FINAL COMMENTS OF
ROCKY MOUNTAIN ENERGY COMPANY
ON THE
NUCLEAR REGULATORY COMMISSION'S
PROPOSED AND FINAL REGULATIONS
ON
URANIUM MILL TAILINGS LICENSING CRITERIA,
AND THE
DRAFT GENERIC ENVIRONMENTAL IMPACT STATEMENT
ON URANIUM MILLING

(NUREG-0511)

October 24, 1979

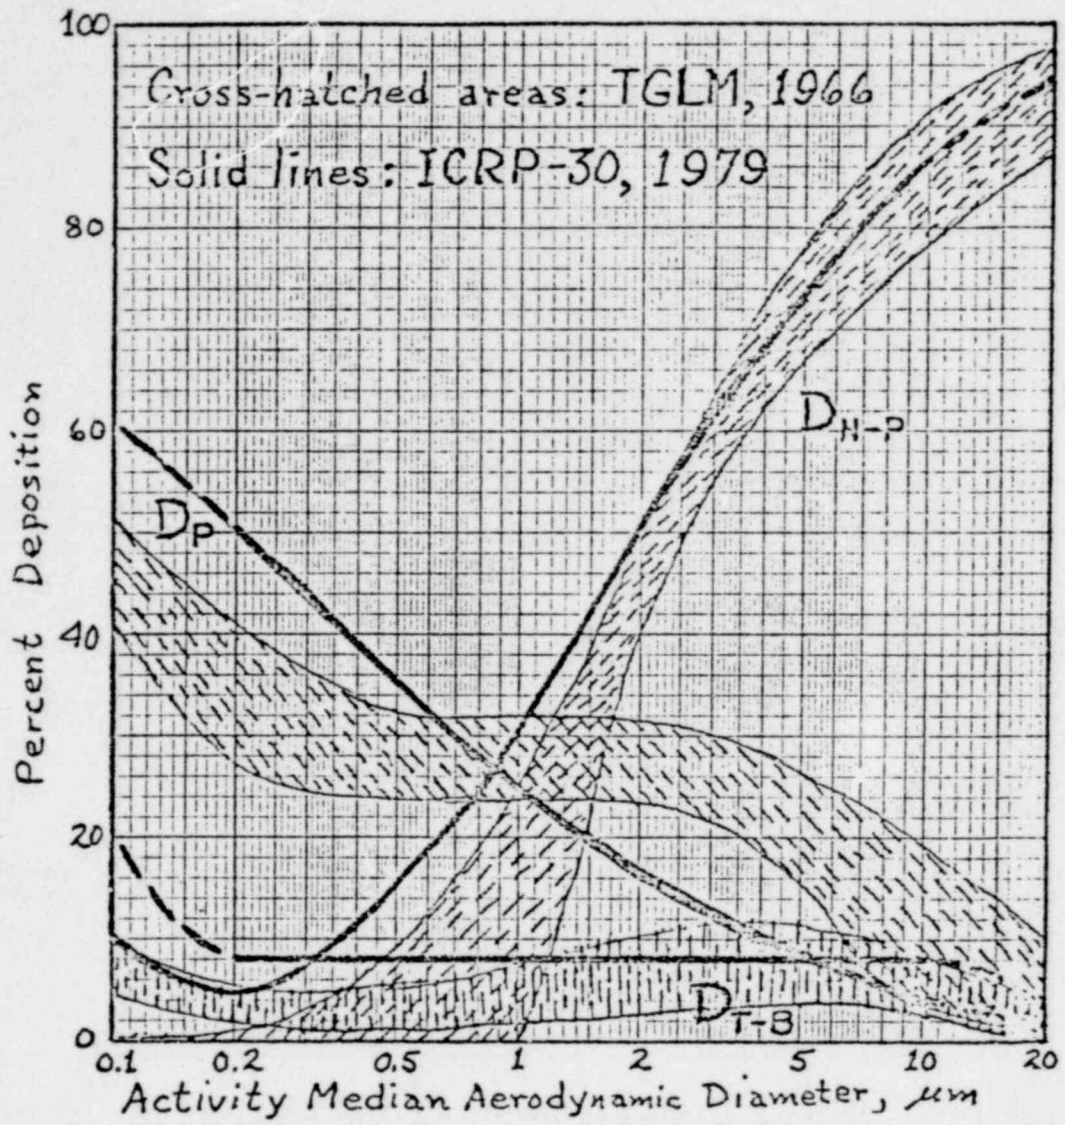
The discussion does not go on to point out that Figure G-1.1 also indicates that about 99.6% of the particles are greater than 50 μm in diameter. By extrapolation of the curve in Figure G-1.1, one might estimate that at least 99.99% of the particles exceed 1 μm in diameter.

Since the mass of a particle is proportional to the cube of the diameter, it is obvious that the smallest particles (e.g., less than 5 μm) in a distribution having a MMAD of 500 μm (as indicated in Figure G-1.1) must account for an exceedingly small fraction of the total mass. In spite of this obvious implication of the data, the source term was assumed as follows:

"the staff has assumed a release rate of one metric ton (1.1 ST) per year having a particle diameter of only 1.0 μm . This is a somewhat arbitrary choice which is believed to be conservative with respect to radiation dose estimates." (p. G-2)

If the data in Figure G-1.1 had been plotted as a log-normal distribution, as recommended by the TGLD, this gross error in the source term estimate for ore dust would have been obvious and avoidable. Similar discrepancies appear to have been incorporated into the equivalent estimates of dust release rates from tailings piles.
